Docket Item #7
BAR CASE# 2005-0055

BAR Meeting
April 27, 2005

ISSUE: Addition and alterations

LOCATION: 421 North Fayette Street

Figure 1- Site Plan

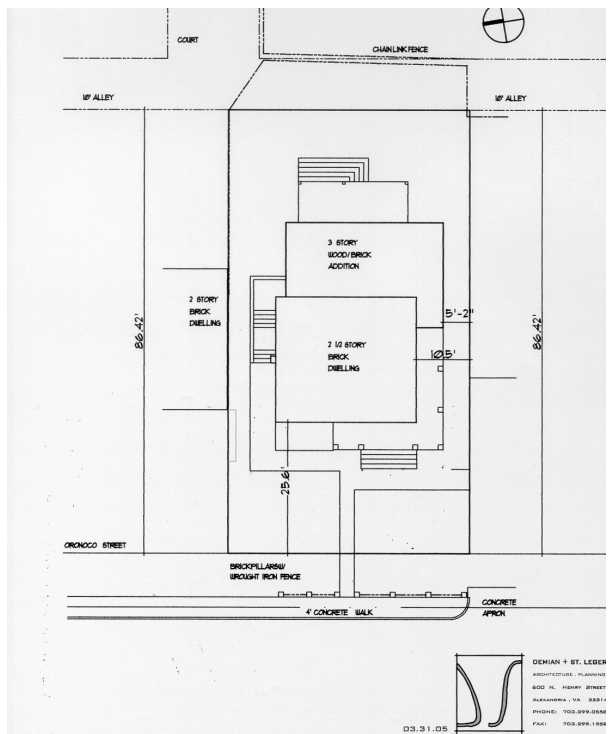
The applicant is requesting a Certificate of Appropriateness for an addition and alterations to the existing two story detached brick house. The existing house has 1953 gross square feet of area. The proposed addition will add approximately 1857 gross square feet. A three story frame addition will be located at the rear (east) elevation and wrap around the southeast corner of the house.
